14/27-92A REVISED 23411 Ridge Road
Cedar Grove Historic District

HISTORIC PRESERVATION COMMISSION STAFF REPORT

Address: 23411 Ridge Road Meeting Date: 2/24/93
Resource: Cedar Grove Historic District Review: HAWP/Alteration
Case Number: 14/27-92A REVISED Tax Credit: No
Public Notice: 2/10/93 Report Date: 2/17/93
Applicant: Janet & Steven Wells Staff: Nancy Witherell
PROPOSAL: Build rear addition RECOMMEND: Approve

NORTH ELEVATION

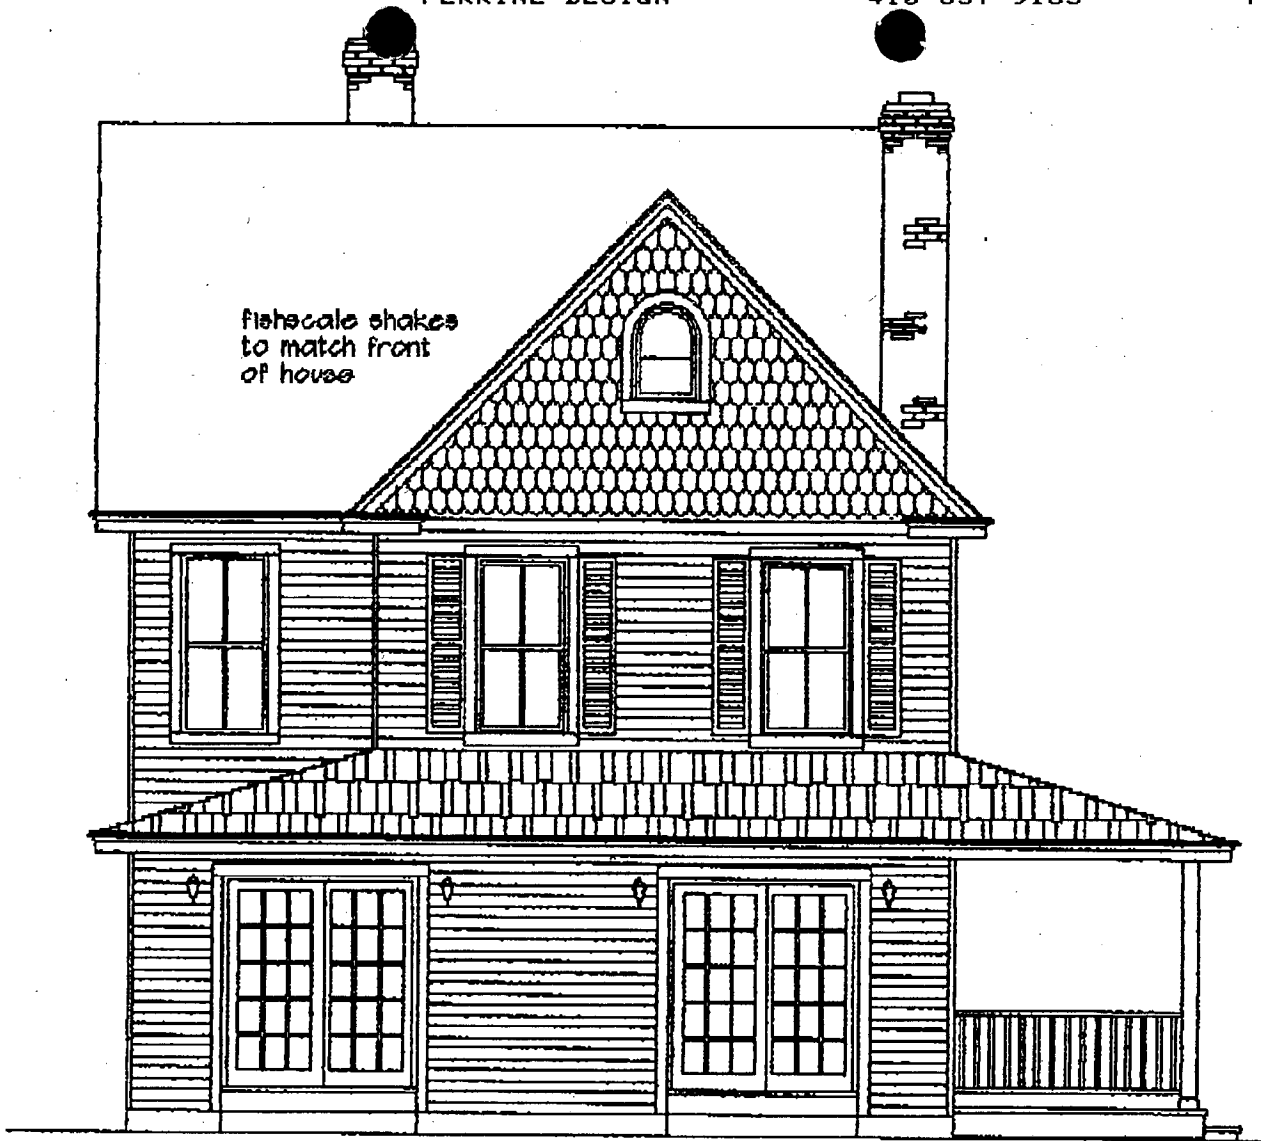
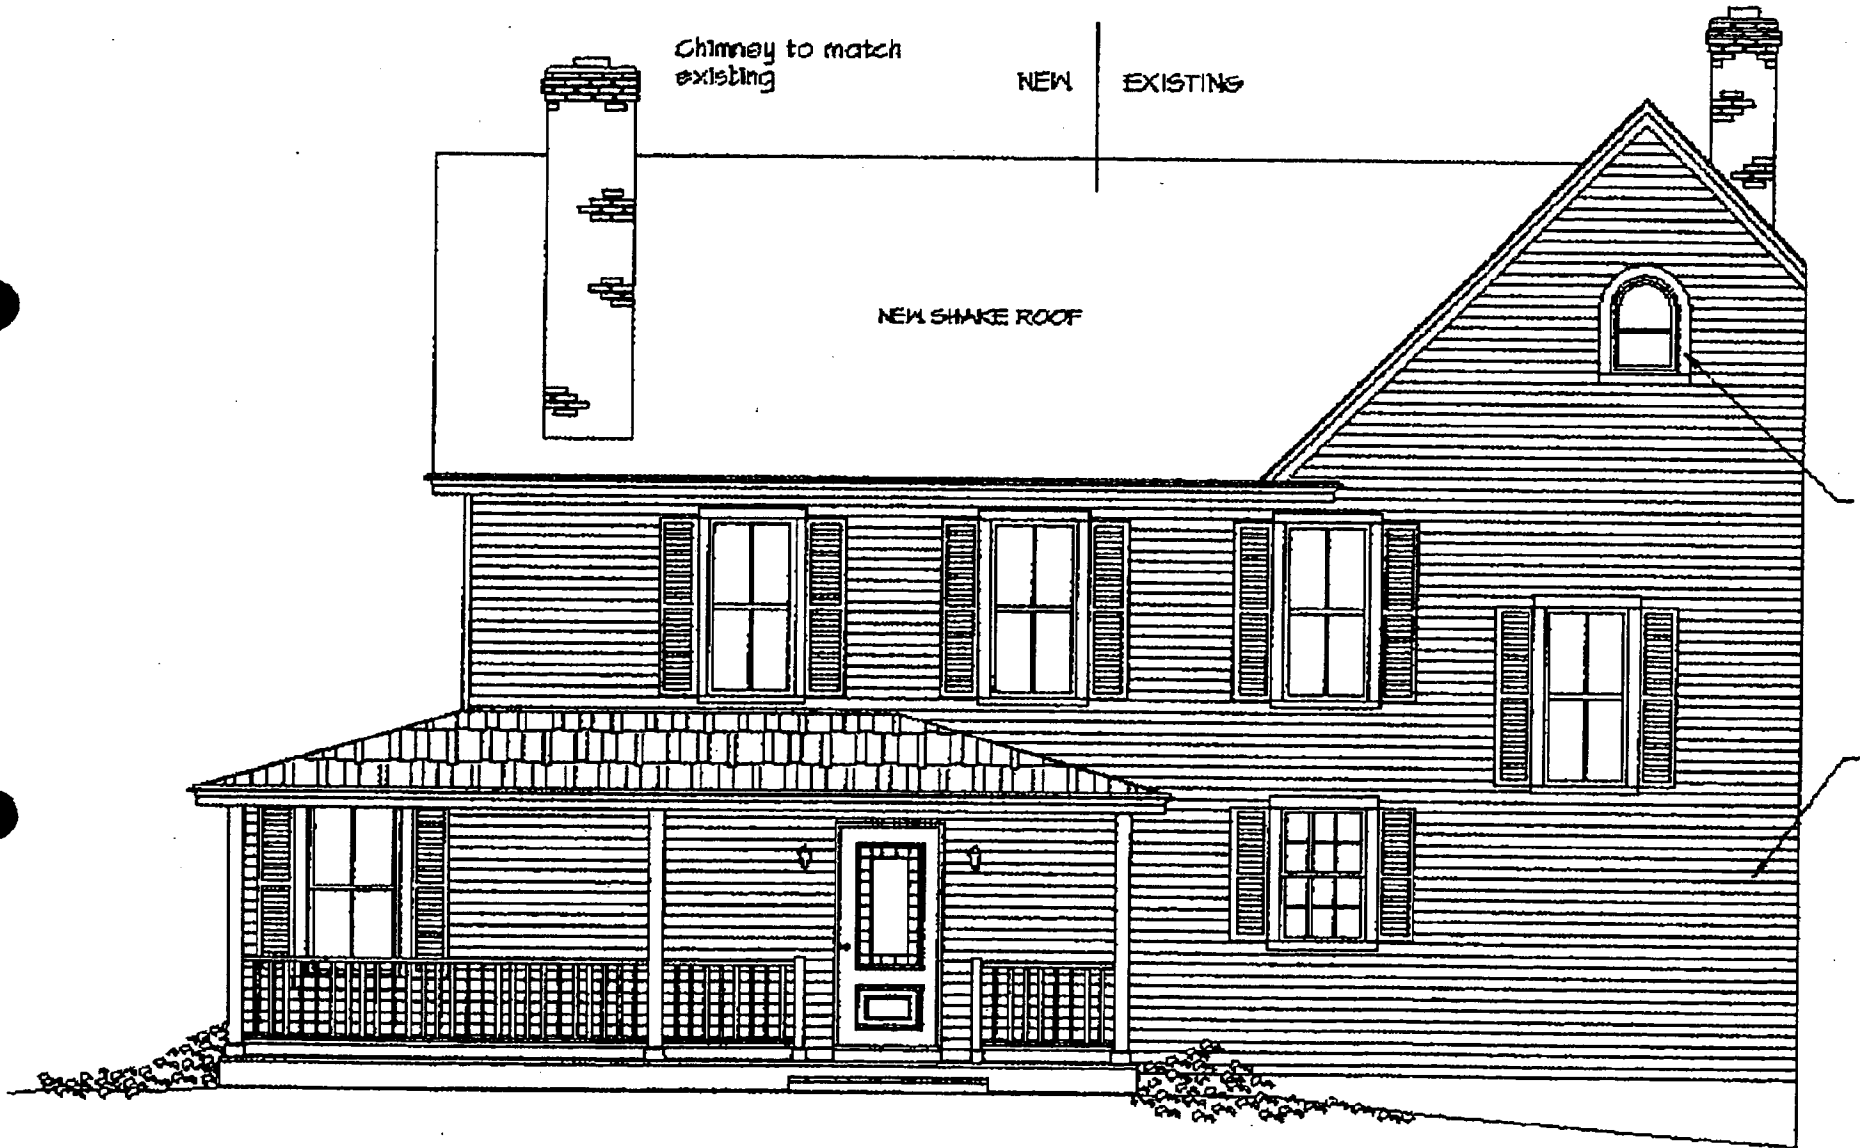
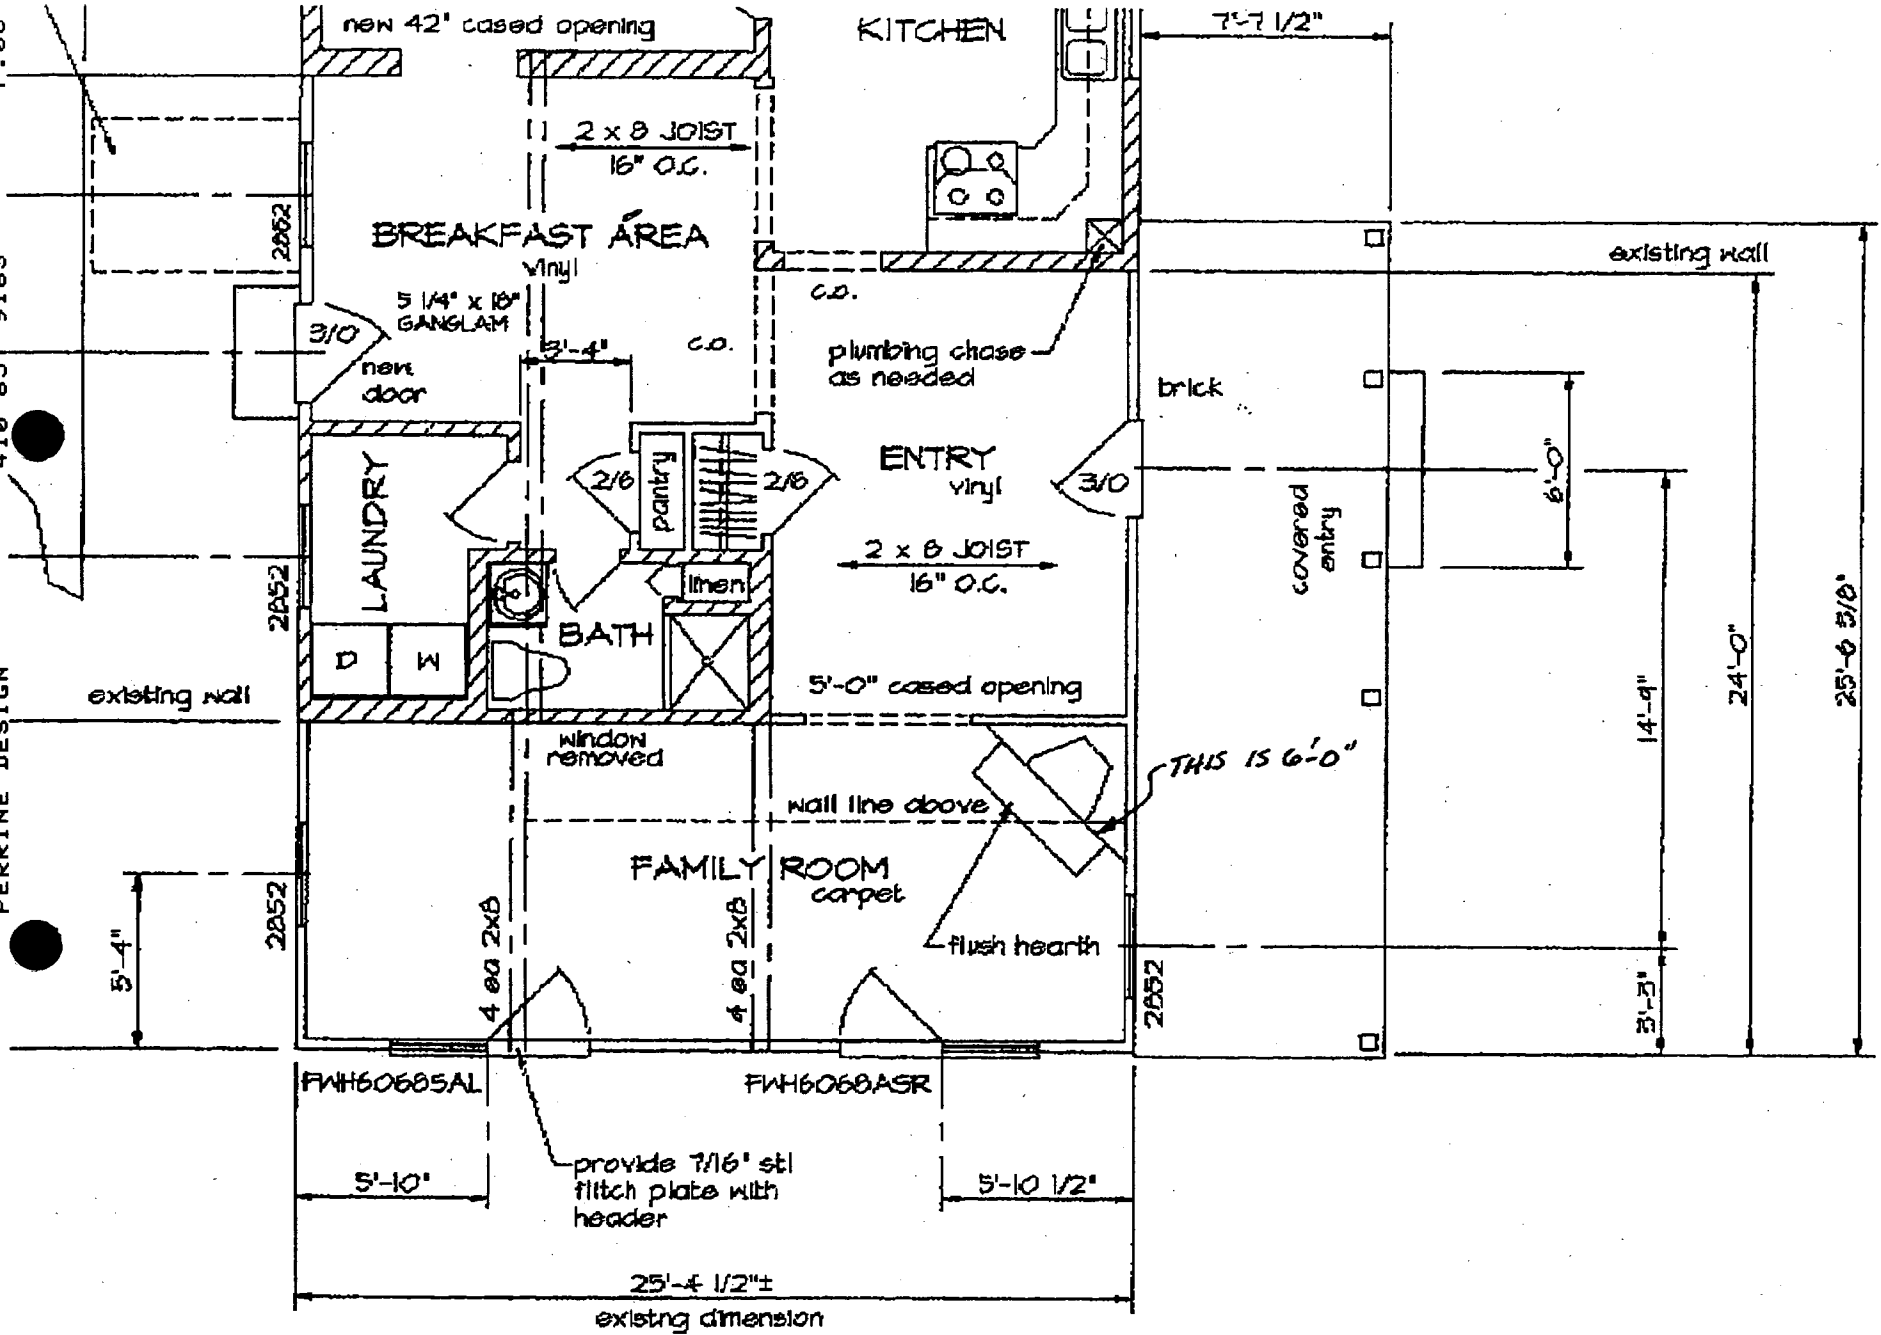
The revision proposes continuing the hip around the north elevation of the new addition. This has the benefit, in the staff's judgment, of continuing the roof form in a more natural way, and of integrating the new door on the north elevation with the wrap-around rear porch. No articulation of the door surround is necessary. The result would be a door that would appear to be secondary to the front door.

The staff finds this proposal to be an improvement on the December submission, not only in the massing and design of the rear addition's roof, but in the detailing of the north door, the reworked chimney capping, and the more compact fenestration pattern on the north elevation.

1. The enclosed elevation drawings incorporate the changes discussed with you on the phone. We have added a wrap-around porch on the north side and removed the double windows on the first and second floors. We think that this fits in better with the existing house. We also replaced one set of double windows on the east side with matching "French" doors. The chimney has been enclosed in the wall on the north side also.

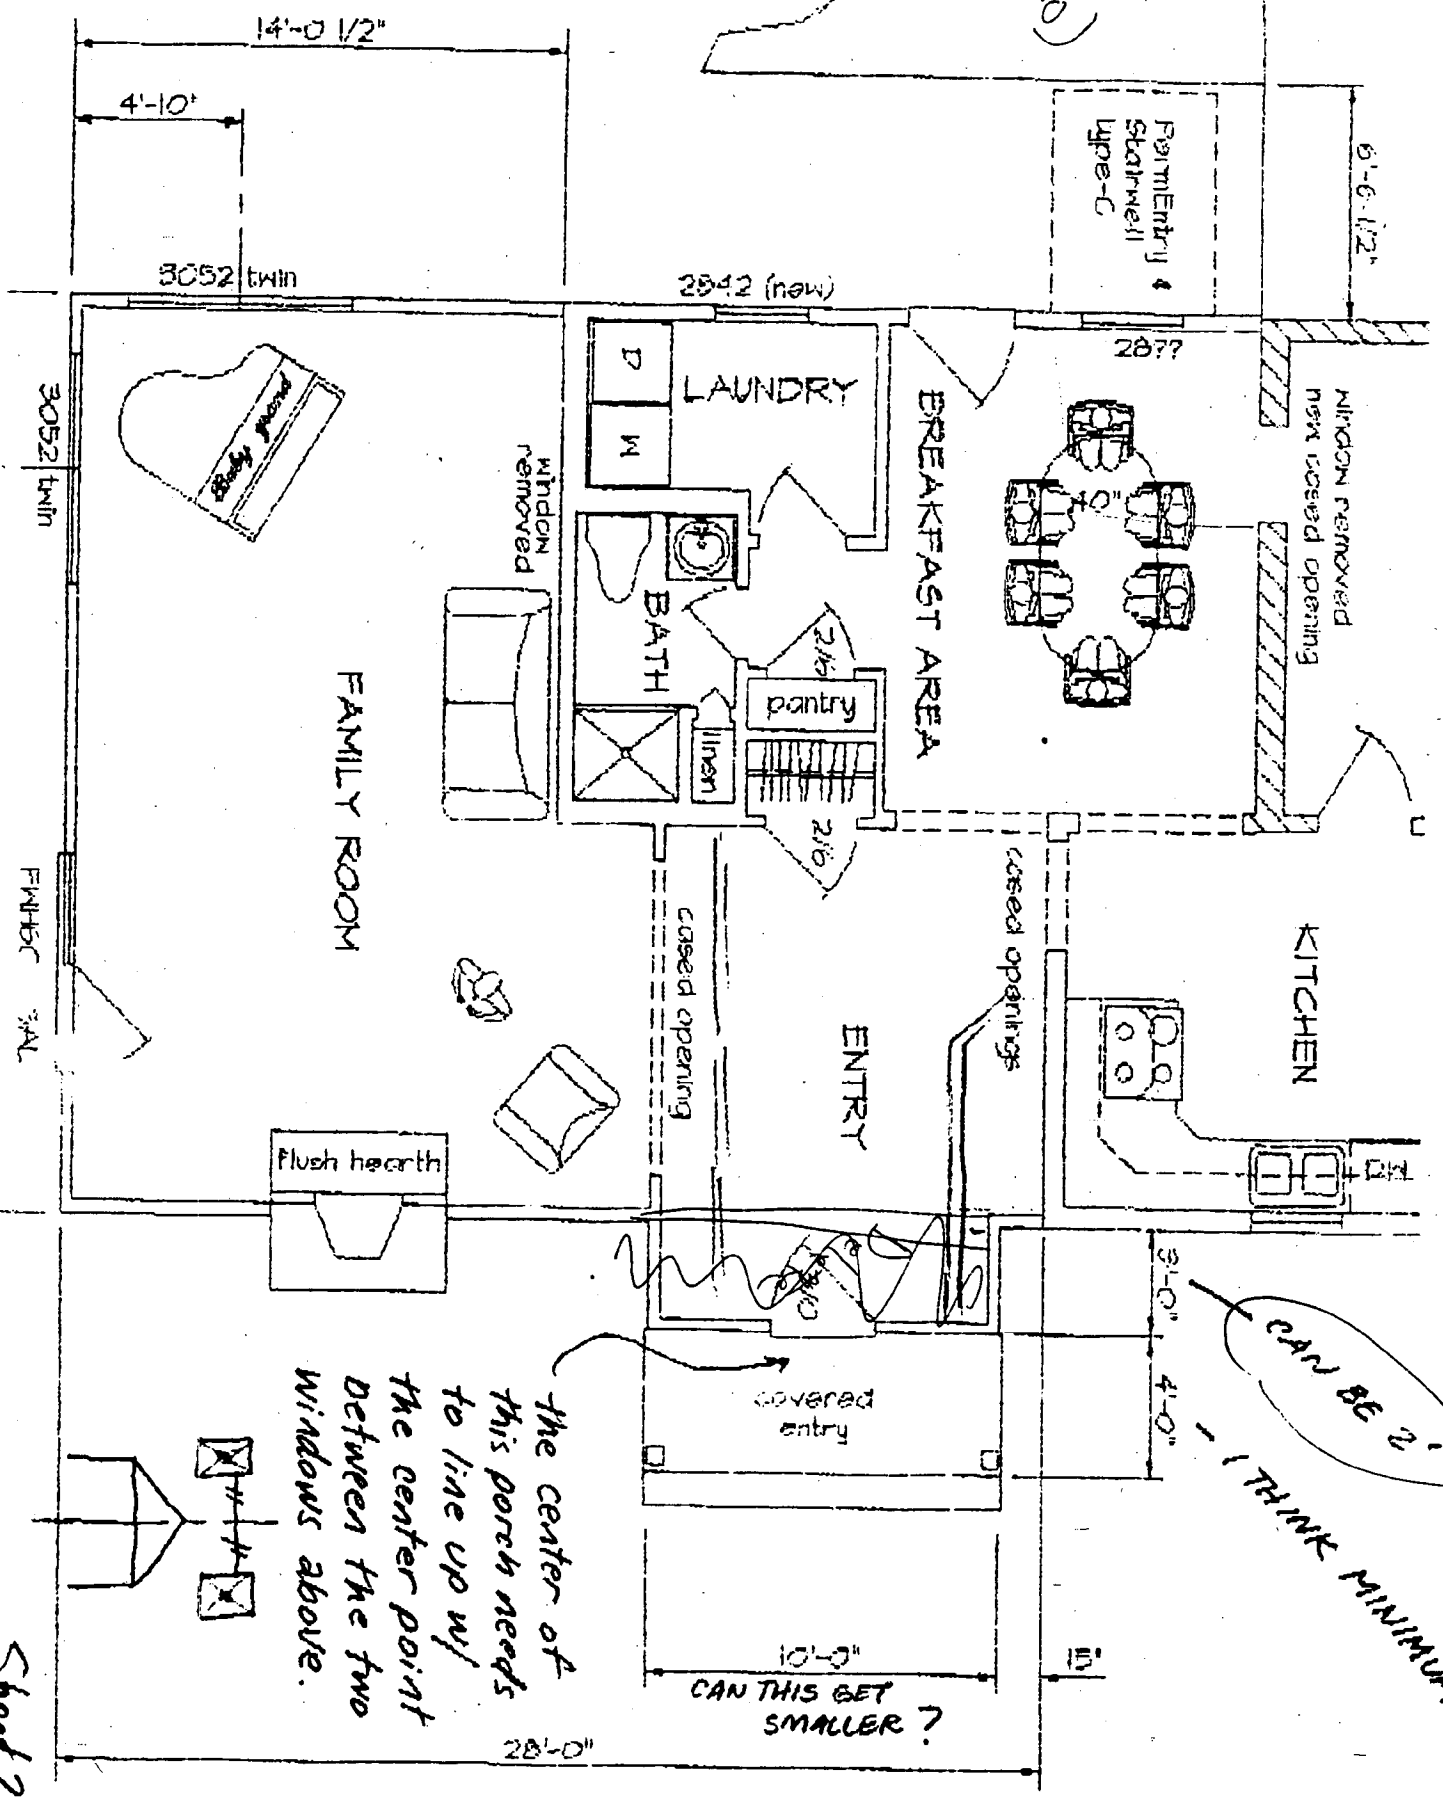
CAN BE 2'
- I THINK MINIMUM

the center of
this porch needs
to line up w/
the center point
between the two
windows above.

CAN THIS GET
SMALLER?
